**Beneficial Use of Dredge Materials
for the Improvement and Enhancement of
Eastchester Bay Wetlands and the Water Based Economy
of the Eastern Bronx**

Draft Environmental Impact Statement

**Public Notice #97-13010- Y2
Royal Marina Application**

July 13, 1998

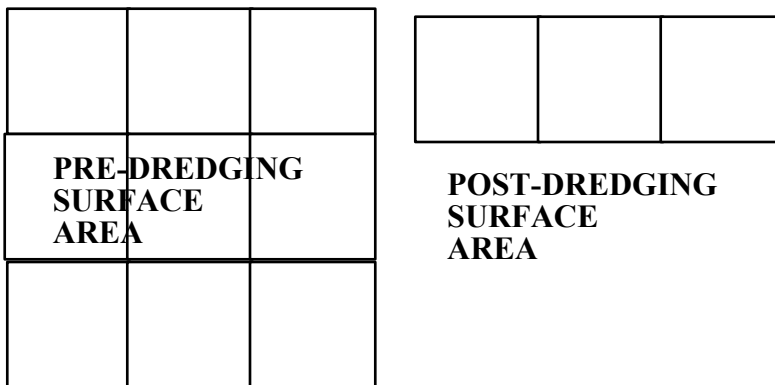
11. Pages 1 - 4 of the Technical Appendix focus on two primary means by which any contaminants will be reduced in effective concentration or eliminated: changes in gross interfacial geometry of dredged sediments within the containment facility; and, increased (bio)geochemical capacity of COC removal by containing sediments beneath the envelope of a developing saltmarsh rhizosphere, and by increasing the diversity of biogeochemical systems.

"Calculations characterizing the surface to volume ratio of the proposed containment configuration indicate that this structure will reduce the release of COCs contained in the dredged material to the water column by a factor of about three, i.e., a three fold reduction in the ratio of the sediment/water column interface to sediment volume will lead to about a threefold reduction in the movement of COC's through sediment surfaces."

This will lead to a change in geometry as shown in Figure 1 in the Technical Appendix, and below, from sediments spread beneath an approximately three acre surface, to packed below approximately a one acre surface. Since contaminants are released through the surface, this step alone will diminish contaminant release.
